1992 Corvette ZR-1: Service Bulletin: Lack of Wide Open Throttle Engine Underpower

Subject: LACK OF WOT-LOW ENGINE POWER REVISED CABLE ADJUSTMENT PROC.

Model and Year: 1992 CORVETTE ZR-1 WITH 5.7L ENGINE AND MANUAL TRANSMISSION

Bulletin Number: 92-214A-7B - (07/01/1992)

THROTTLE BODY AND ACCELERATOR PEDAL CABLE ADJUSTER

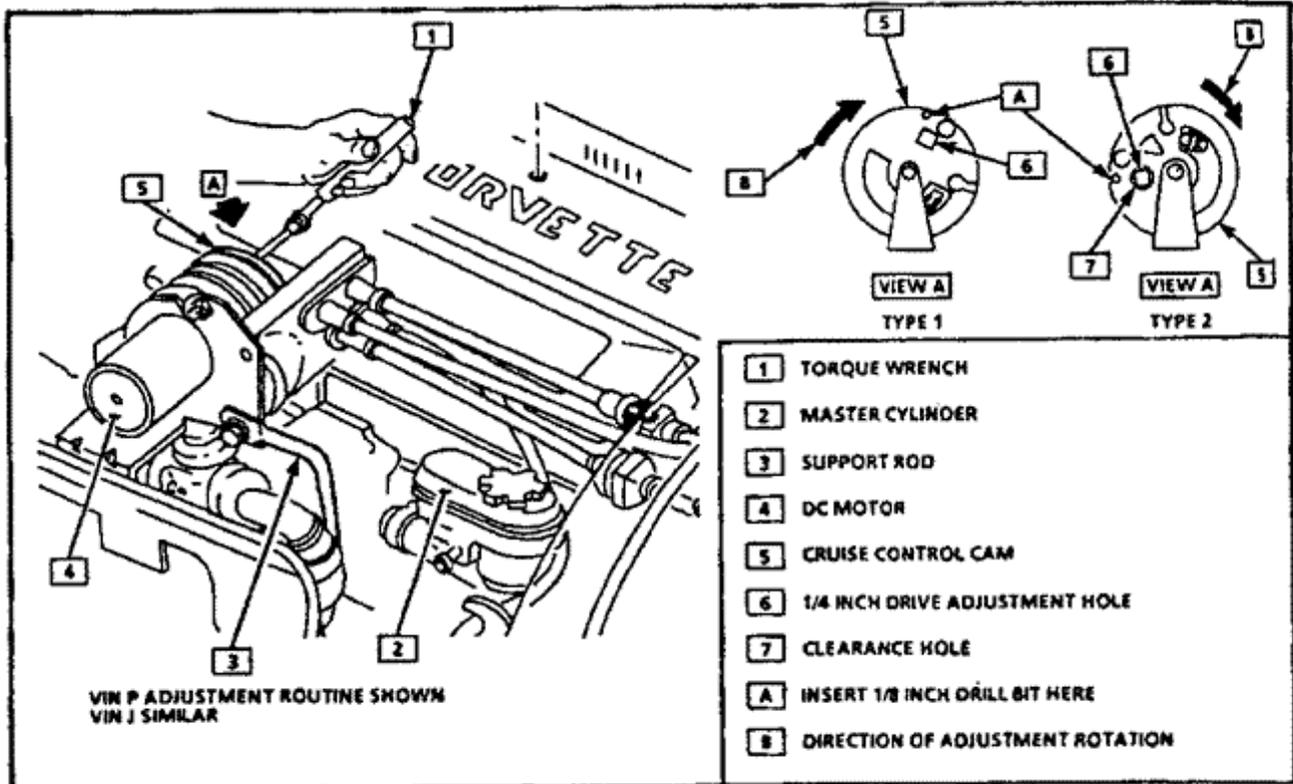
1. Remove adjuster cam assembly splash cover, foam shield, and cable cam cover.
2. Disconnect cruise control cable from the cruise control servo.
3. Depress reset button on the throttle control cable and fully extend cable sheaths (see figure).
4. Insert a 1/8 inch drill bit into adjuster assembly alignment hole (see figure, item A).

5. Insert a torque wrench with a 1/4 inch drive extension into square hole on the cruise control cam (type 1) or through the cruise control cam into the accelerator cam (type 2) (see figure, item 6).
6. Turn the torque wrench clockwise until obtaining a torque of 4 N.m (35 lbs. in.). During adjustment, several clicks of the adjuster should be heard. If not, repeat step 3.
7. Remove the torque wrench AND drill bit.

• ALWAYS MAKE SURE CABLE SHEATHS ARE AT THEIR FULLY EXTENDED POSITION BEFORE PERFORMING ADJUSTMENT PROCEDURE
